McCULLOCH CORPORATION
SERVICE BULLETIN

1539

MODEL: 10 Series, SP 80, SP 81, SP 60, PM 60

SUBJECT: PULSE PUMP GASKET

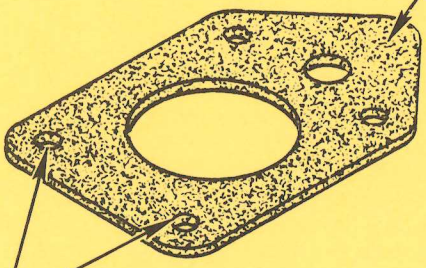
An improved Pulse Pump Gasket, P/N 89642, is now being used on SP 80, SP 81, SP 60, PM 60, and Mac 10 Series chain saws. The new gasket provides better alignment on saws with single screw pulse pump mounting. On earlier Mac 10 Series saws with three screw mounting, the old gasket, P/N 88782, must be used. Differences between the new gasket and the earlier gasket may be noted in the size of the screw holes as illustrated.

OLD

Mac 10 Series
(3 Screw Mounting)

NEW

Mac 10 Series
(1 Screw Mounting)
SP 80, SP 81
SP 60, PM 60

Use the illustration above to determine the proper replacement.
